STAFF RECOMMENDATION

413 N 16th Street

August 19, 2020

Application: New Construction—Addition

Figure 5. The addition's connection to the historic ridge alters the historic roof form inappropriately.

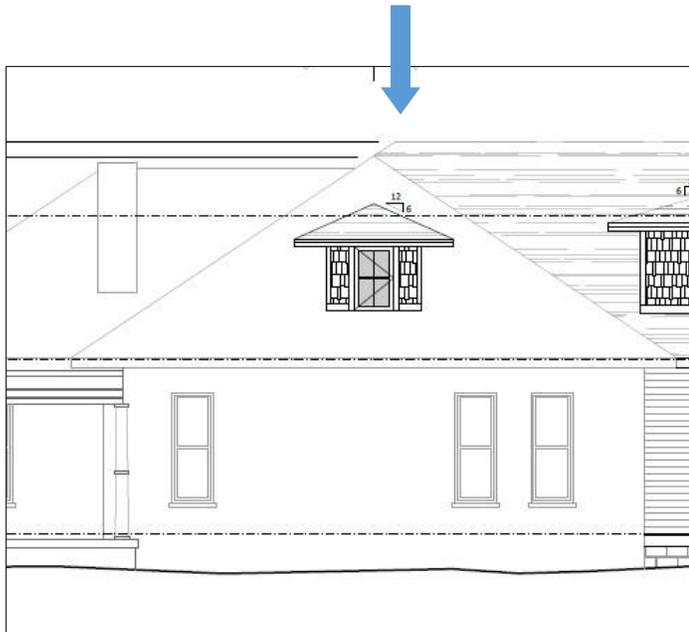
Roof form: The addition has a gabled roof with 8/12 pitch. It is connected to the existing hipped roof with a continuation of the hip upwards one foot (1') and requires removal of the majority of the left-rear, original, pyramidal, ridge line. As discussed in Height and Scale, the additional height could be appropriate, however staff finds the method of the connection to the addition to be inappropriate, as it changes the form of the roof and is not sufficiently differentiated from the roof of the historic building (Figure 5). The right side meets the design guidelines; however, the left side wipes out the existing ridgeline. In the past, the Commission has tried to retain the ridgelines as a way to maintain the original form and allow for an addition to be removed in the future, if original conditions were ever desired to be restored (II.B.10.d.). Section II.B.10 for additions states that additions that tie into the existing roof should do so at least six inches (6'') below the ridge line. Staff recommends that the addition's roof is revised for the addition to meet the ridge of the house at least six inches (6'') below each existing ridge.

1. The addition's roof form is revised for the addition to tie into the existing roof at least six inches (6") below the ridges;
2. The left side dormer is either removed or redesigned so that it sits on the new addition only;
3. The horizontal window on the addition's right side is redesigned to be at least two traditionally (2:1) proportioned windows; and,
4. Staff approve the final details, dimensions and materials of windows, doors and roofing color prior to purchase and installation.

Figure 7. The dormer stretching across the new and historic roof forms is not a compatible roof form.

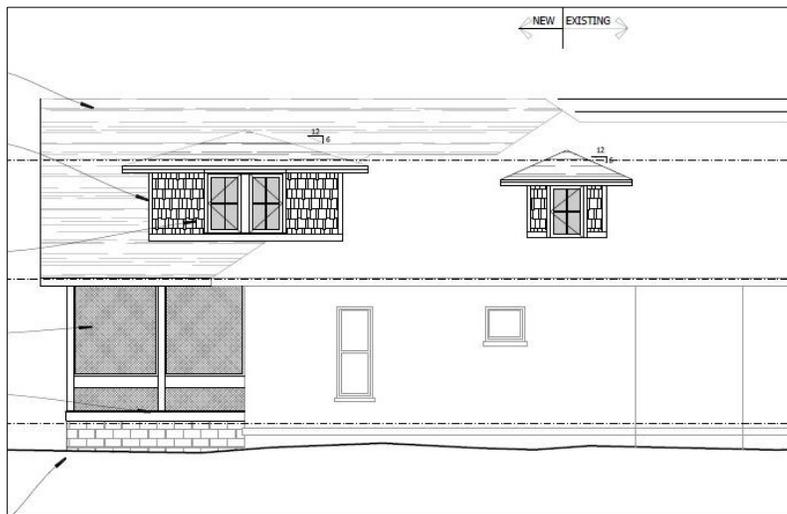
The sides of the addition also include fourteen foot and one inch (14' 1") wide dormers. Dormers on an addition may be larger than what is required for a historic building, depending on their scale and location. Typically, the front face of dormers should be primarily glazing, as seen historically. The right-side rear dormer's face is not primarily glazing; however, it is located in a minimally visible location. The dormer on the left side does not meet the design guidelines as it destroys the original roof form. Staff recommends that the dormer be redesigned so that it sits only on the roof of the rear addition in a manner that retains the original roof ridges.

Staff recommends the left side dormer be removed or redesigned so that it does not span both the old and new roof form.

Figure 8. Staff recommends this long horizontal window is broken up into at least two traditionally proportioned windows.

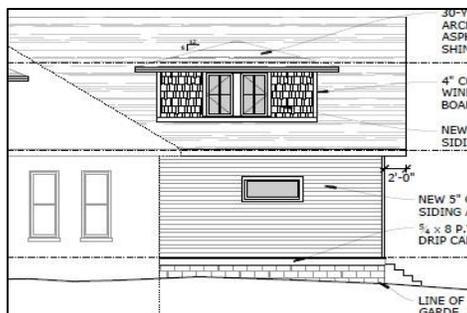
There are horizontal windows on the addition's right side (Figure 8) and on the rear that do not meet the historic window proportions. Although the side window is towards the rear of that façade, Section II.B.4 states that the window pattern should not contrast greatly with surrounding historic buildings. Because the location of the rear window will not impact the character of the house, as seen from the street, Staff finds it to meet the design guidelines. Staff recommends that the window on the right side of the addition is revised to be more compatible, with at least two traditionally proportioned windows. The horizontal window is likely desired because the interior use is a closet; however, windows with 2:1 proportion could be enclosed by shutters or could have opaque glass allowing the interior to be walled-over, if desired. With this condition, staff finds the project's proportion and rhythm of openings will meet Section II.B.7.
